July 17, 2009

Mr. Matthew Naud, Environmental Coordinator
City of Ann Arbor
100 North Fifth Avenue
Ann Arbor, MI 48104

Re: Evaluation of the Report on Water Level Testing Under Reduced Flow Conditions, Pall Life Sciences – Evergreen Area

Figure 1. "Corrected" and Uncorrected Water Levels at LBOW-1

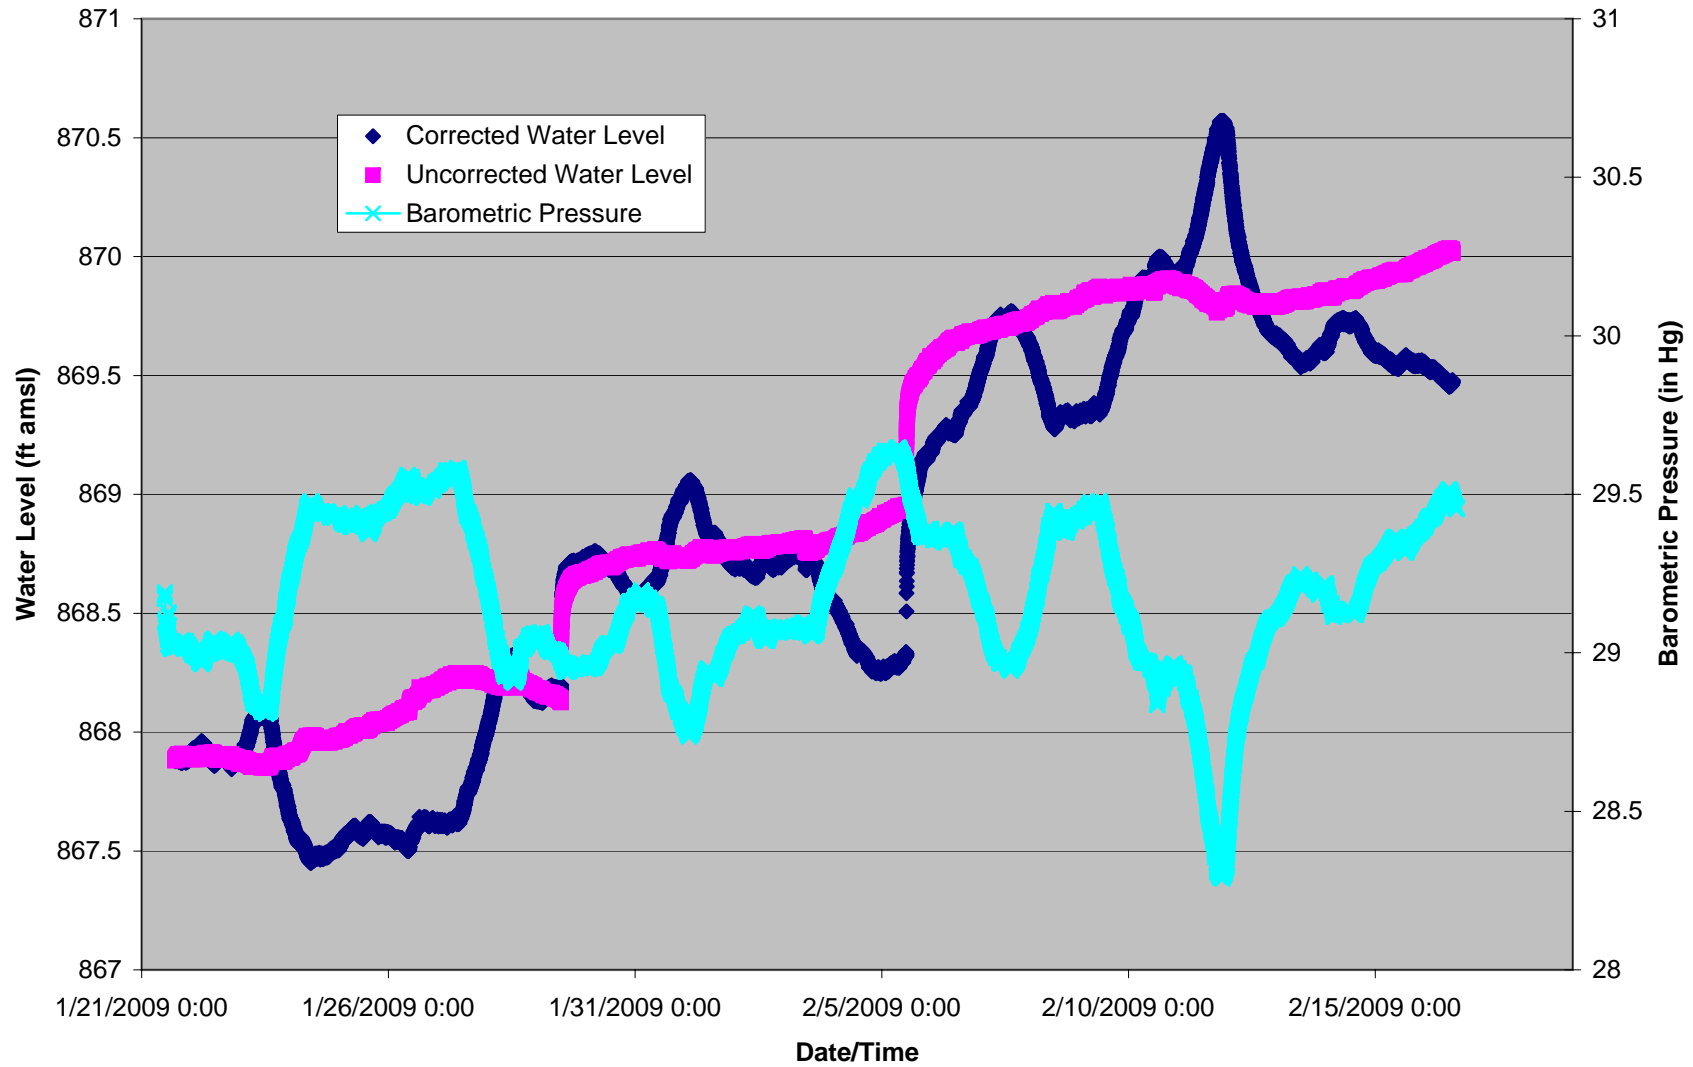
To evaluate the transient behavior of water levels in this case, it may not have been appropriate to fully compensate for barometric pressure changes because the variations within the open well are not representative of what is occurring within the rest of the aquifer. Figures 1 and 2 illustrate the pressure transducer water levels at LBOW-1 and MW-113 “corrected” for barometric pressure along with the barometric pressure signal and the uncorrected or absolute pressure measured at these two wells. It is evident that a significantly smoother trend, which is more representative of a typical water level trend, is achieved when the data are not corrected for barometric pressure. The influences of the shutdown are more clearly observed. In addition, it appears that a background trend of increasing water levels may be present, particularly when observing the time period before the extraction rates were modified (i.e., before 1/29/09).

**Figure 3. "Corrected" Water Levels at MW-120S and
Uncorrected Water Levels at MW-120S, MW-120D, and MW-113**

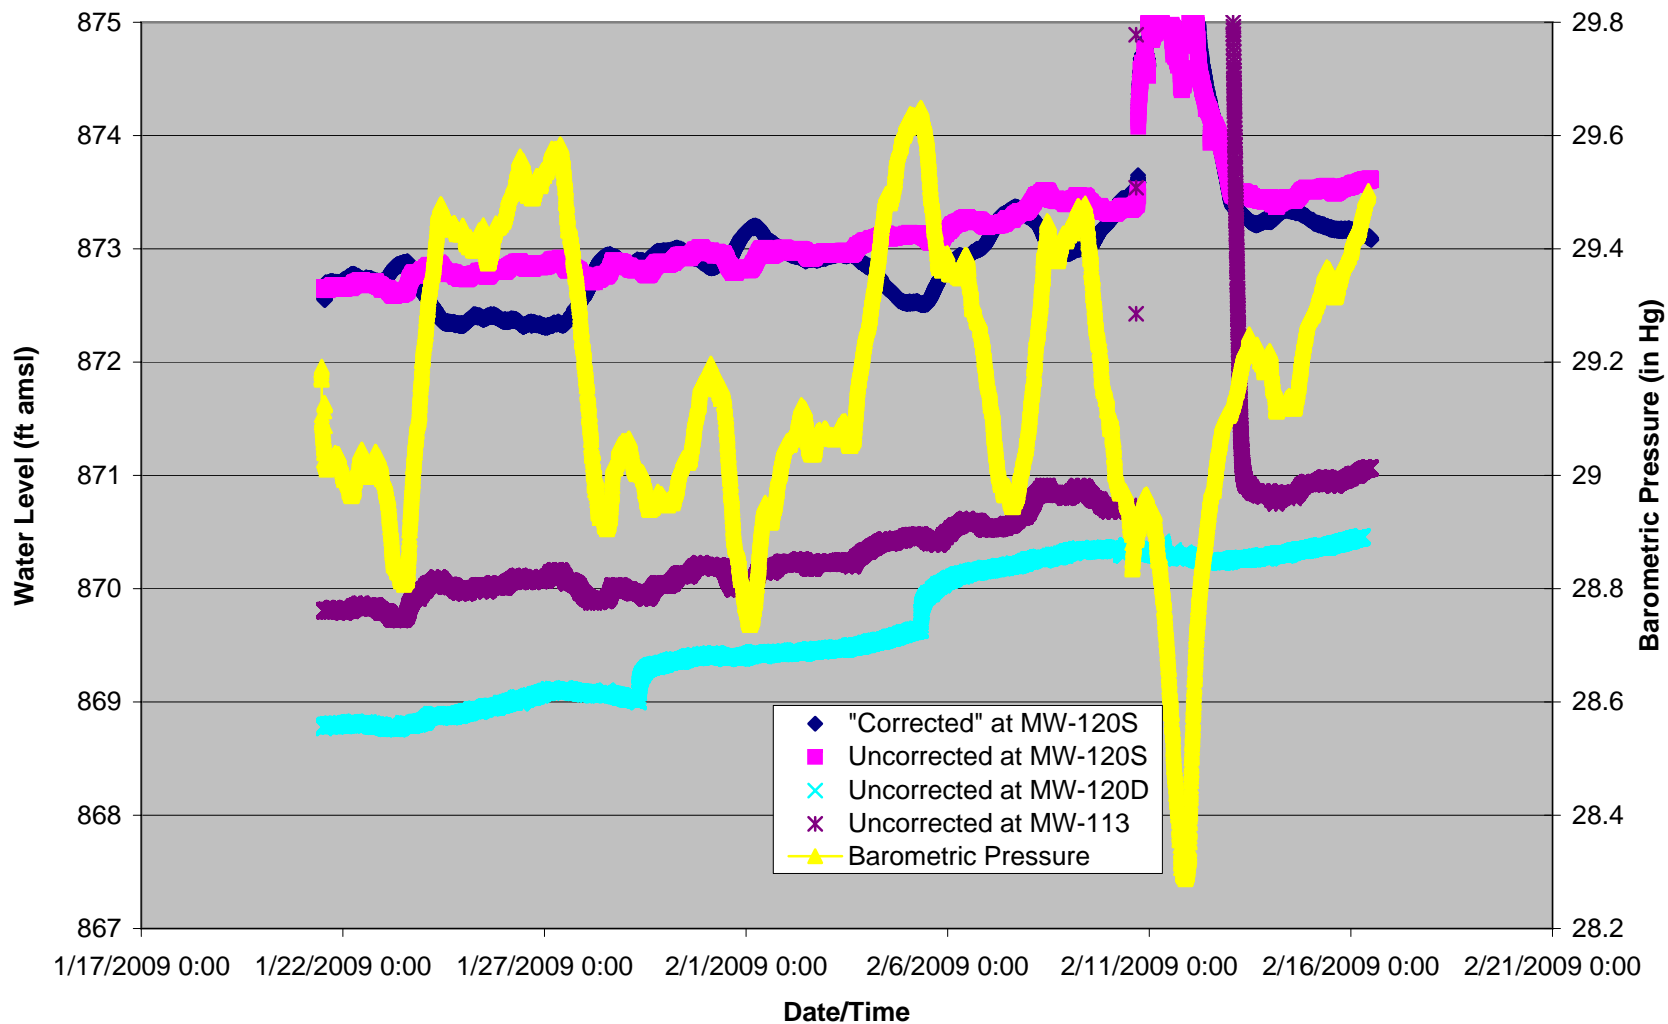
Figure 3 presents the “corrected” and uncorrected data for MW-120S along with the uncorrected data for LBOW-1, MW-113, and MW-120D. It is evident that the MW-120S and MW-120D signals do not show an obvious influence from the change in pumping rates and that the change in water levels appears to be a consistent regional increase with some noise from the barometric changes superimposed. The difference in water levels between MW-120D and MW-120S remain constant throughout the test suggesting a relatively consistent downward gradient in this location. The difference between the water levels at the MW-120 cluster and MW-113 decrease as pumping is discontinued, indicating that pumping enhances the gradient between MW-120 and MW-113, forcing a southerly component to groundwater flow in this location during pumping.

Based on Figure 3, the conclusion that there are indications of influence of aquifer recovery at MW-120D from discontinuing pumping is questionable. It appears that MW-120S and MW-120D are too far from the extraction wells to show an observable influence from the change in extraction rates. Rather, the difference in water levels between pumping and non-pumping conditions appears to result from a background increasing trend in the regional water elevation. This contradicting finding, however, does not appear to affect the primary concern regarding flow direction under reduced or non-pumping conditions.

Figure 4 "Uncorrected" Water Levels from MW-92 and MW-101

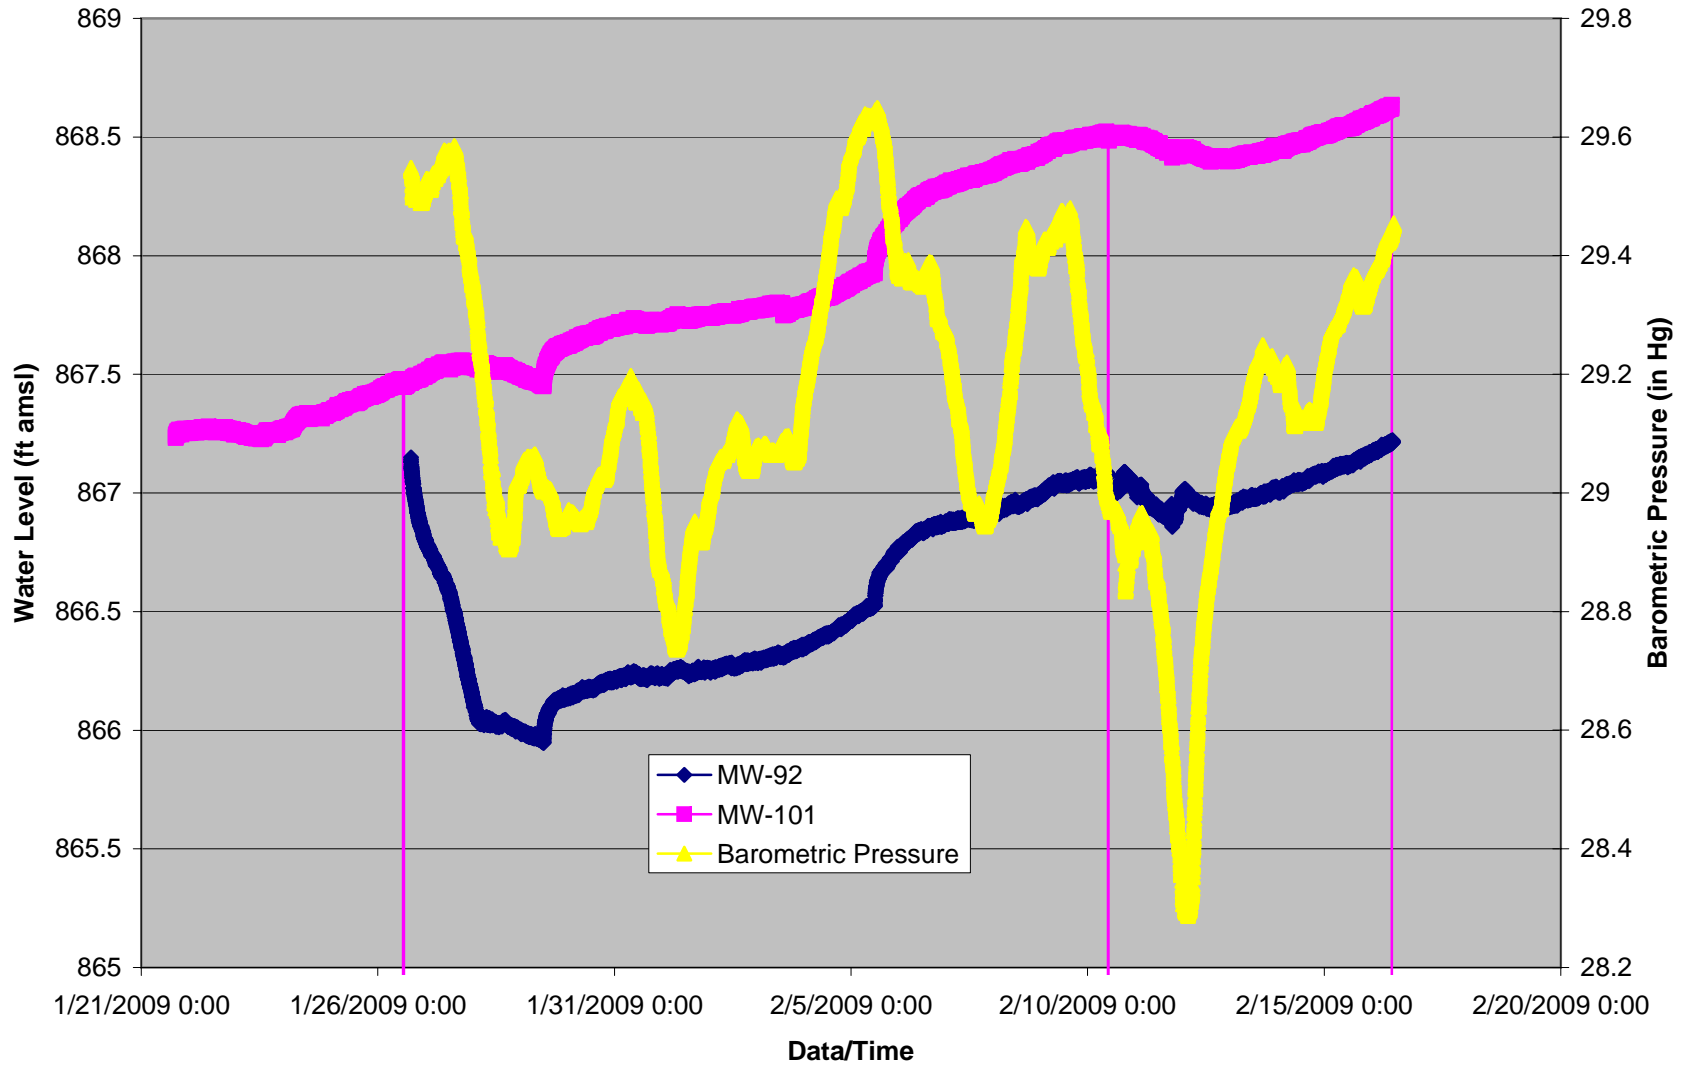
Figure 4 presents the “uncorrected” water levels from MW-92 and MW-101. With the exception of anomalous data at the beginning of the MW-101 signal, the two wells show relatively equal influence from the change in pumping rates. Therefore, it is reasonable to conclude that the wells are influenced by pumping but that there is no observable change in groundwater flow direction between the two wells as a result of pumping.

Figure 5. Uncorrected Water Levels at LBOW-1 with Background from MW-120D Removed

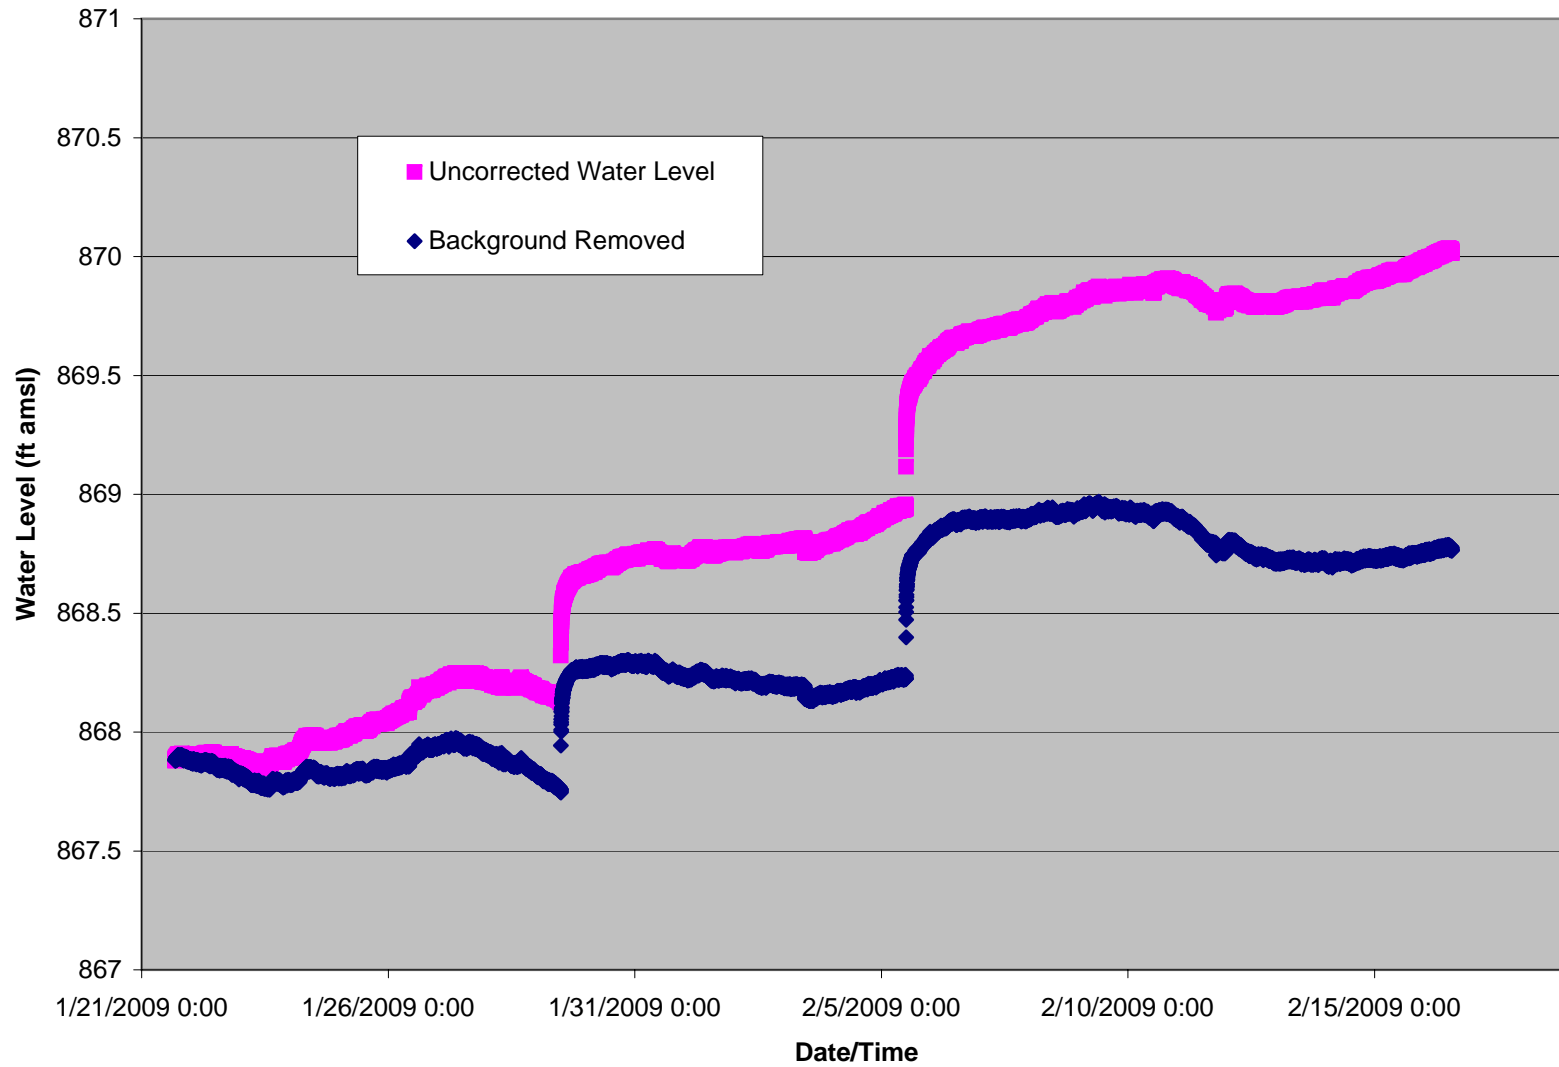
Figure 5 presents the uncorrected water level trend for LBOW-1 and the same trend but with the background (as calculated by MW-120D) removed. With the background removed, it appears that the aquifer in the vicinity of LBOW-1 fully recovered during the test period. Therefore, it is appropriate to interpret the static water levels from February 16, 2009 as being under equilibrated non-pumping conditions.
